HOWARD COUNTY HISTORIC PRESERVATION COMMISSION
ELlicott City Historic District ■ LAWYERS HILL Historic District
3430 Court House Drive ■ Ellicott City, Maryland 21043

2017 Minutes

February Minutes

Thursday, February 2, 2017; 7:00 p.m.

Figure 10 - Drawing shows proposed streetscape with existing and proposed house

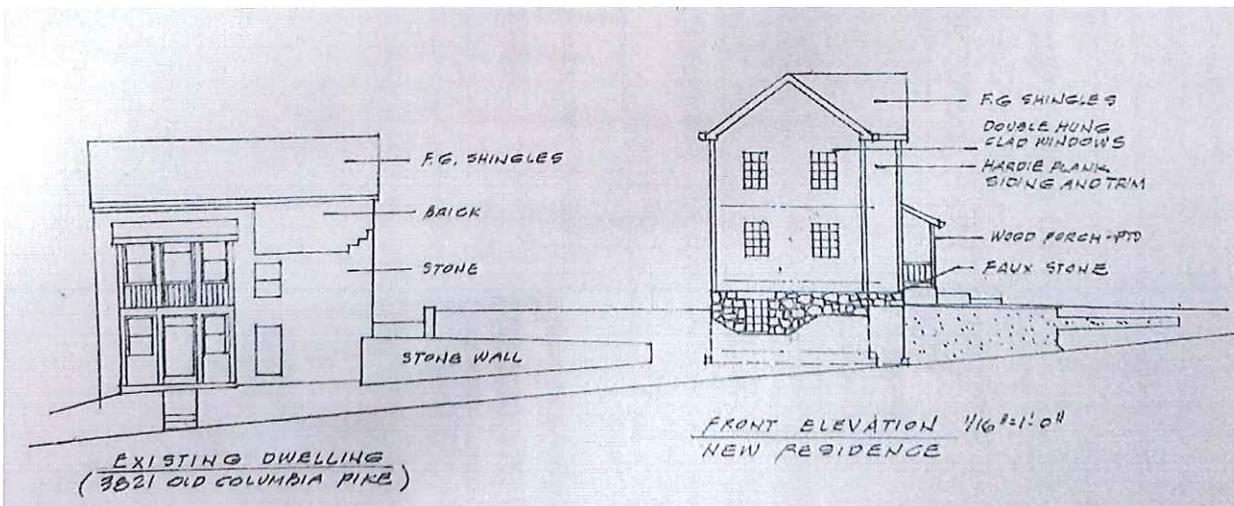
The new building is very modest in size at 20 feet wide, the windows will be wood 6:6 and line up as they historically would on the front façade. The stone foundation is in keeping with the neighboring
